July 13, 2007

**Saturn of West County (Long Road Crossing):** A Site Development Section Plan, Architectural Elevations, Landscape Plan and Lighting Plan for a 5.34 acre parcel zoned "PC" Planned Commercial located at the northwest corner of the intersection of Long Road and Chesterfield Airport Road.

Paul Boyer, of Civil Engineering Design Consultants, Inc., has submitted, on behalf of Butler Investment Partnership, L.P., a Site Development Section Plan, Landscape Plan, Lighting Plan and Architectural Elevations for the above referenced project. The Department of Planning has reviewed this request and submits the following report.

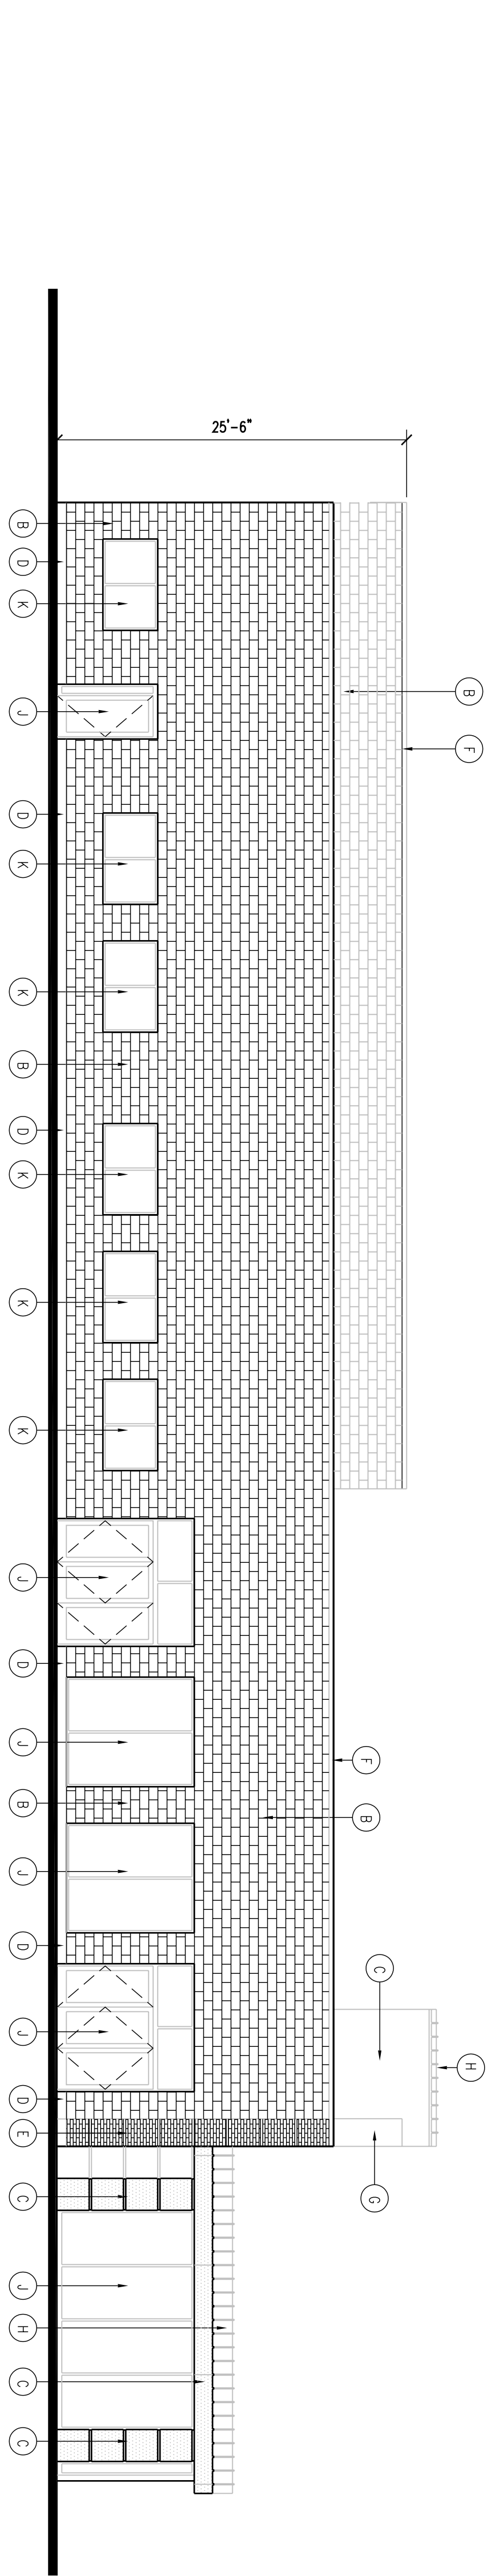
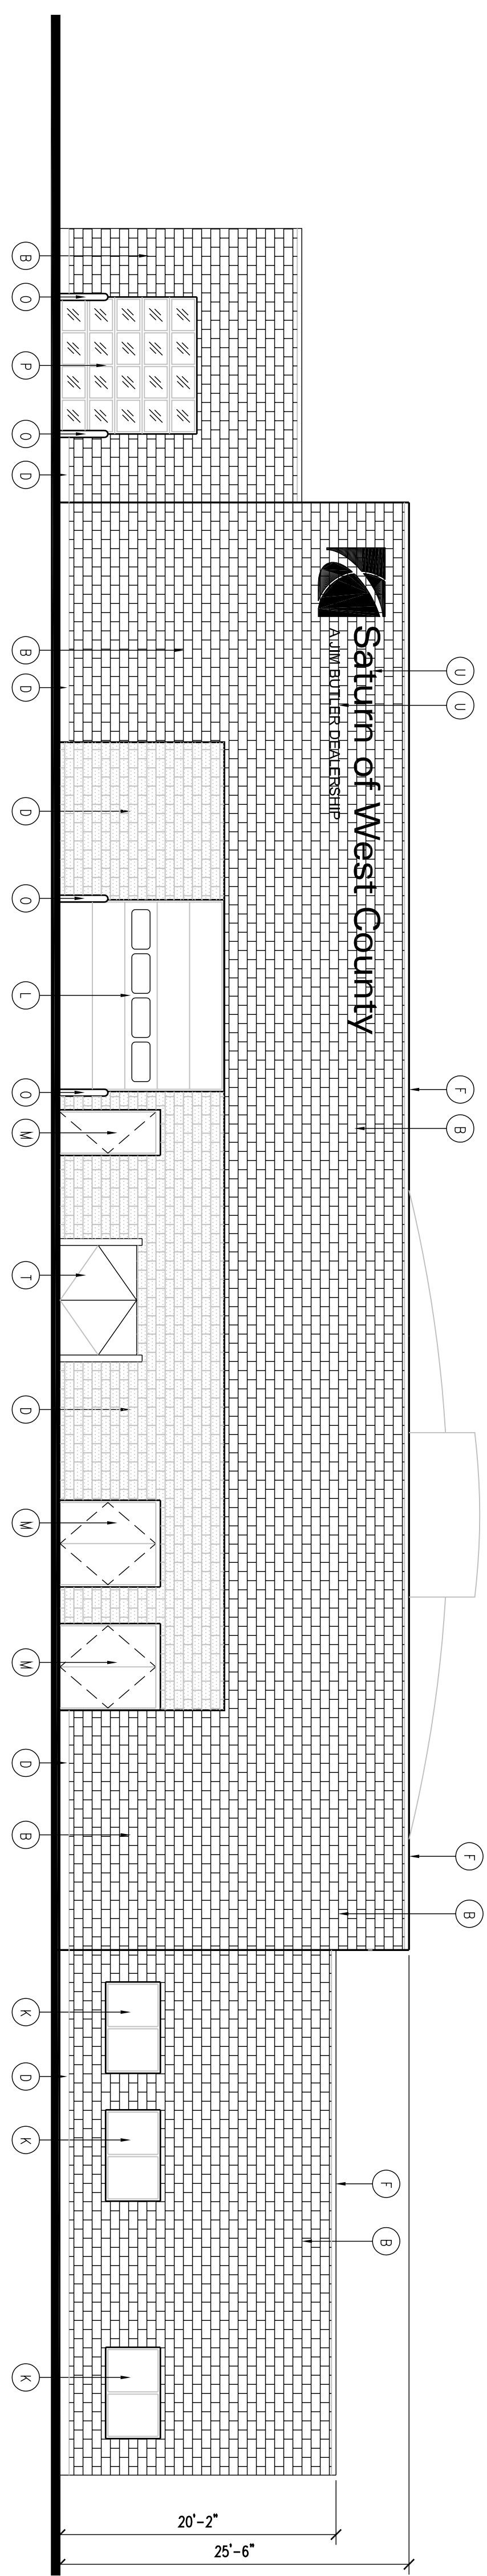
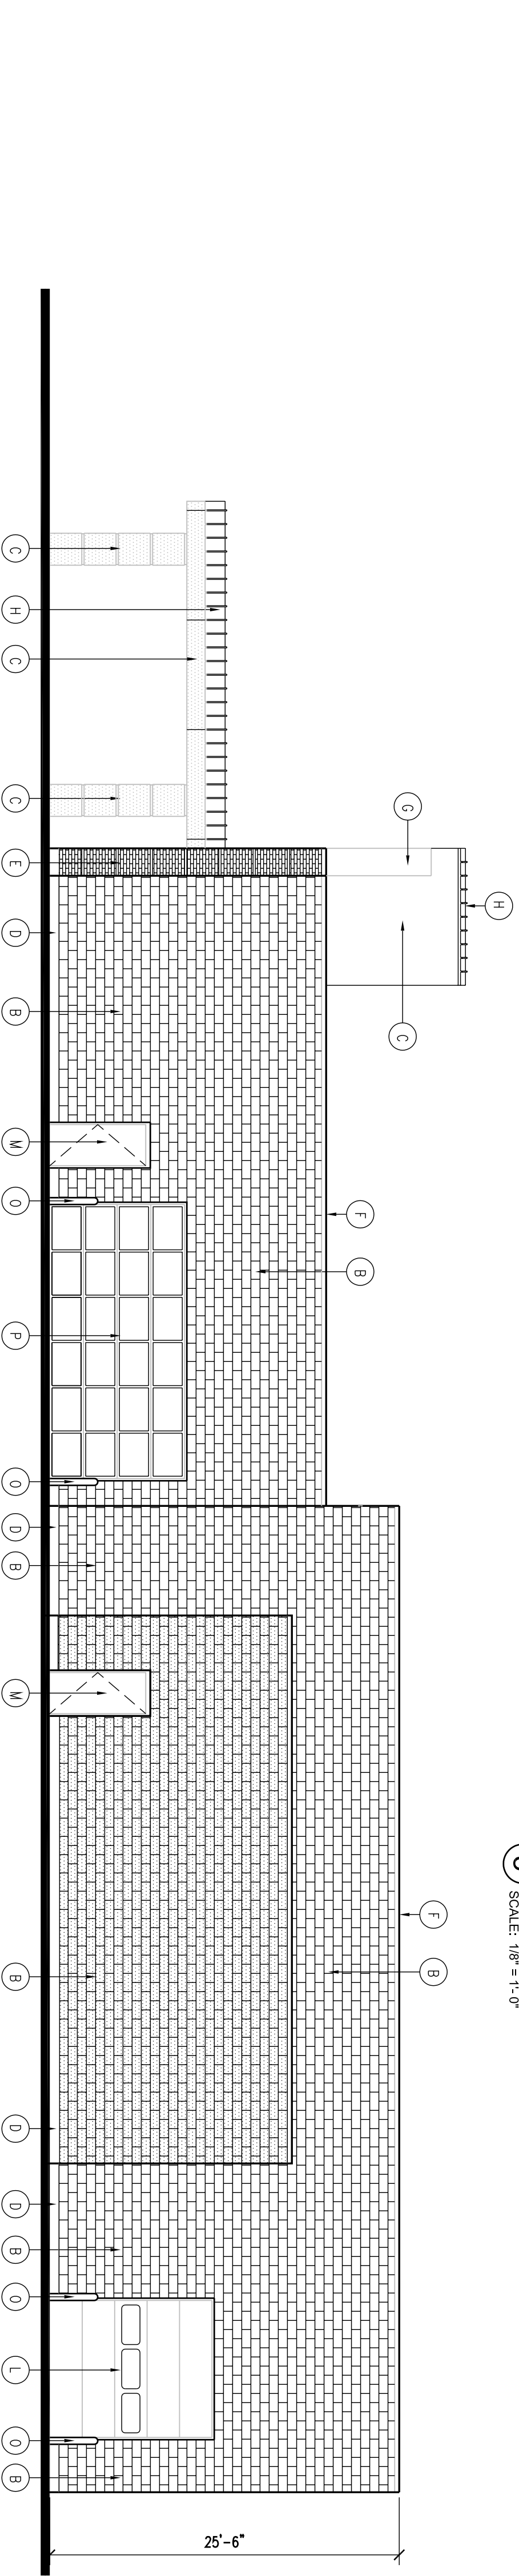
1. The corporate logo feature shown on a red field on both the northern and southern elevations constitutes additional signage and is inconsistent with other developments in Chesterfield Valley. Additionally, the Board is concerned about the proposal to illuminate this area.
2. The location of and lack of screening for the overhead doors facing Highway 40.
3. The use of clay masonry brick instead of split face brick and recommended consideration of a more earth tone color palette.
4. The Board requested that Staff and Planning Commission review the proposed Lighting Plan.
5. The Board requested that Staff review the adequacy of site circulation for delivery trucks.

1. The window box architectural element and curved parapet have been removed from the southern elevation.
2. The overhead doors have been changed to bi-fold glass doors.
3. Brick masonry will be used on the northern façade and split faced and smooth faced concrete, matching the brick, will be used on the remaining façades instead of aluminum panels.
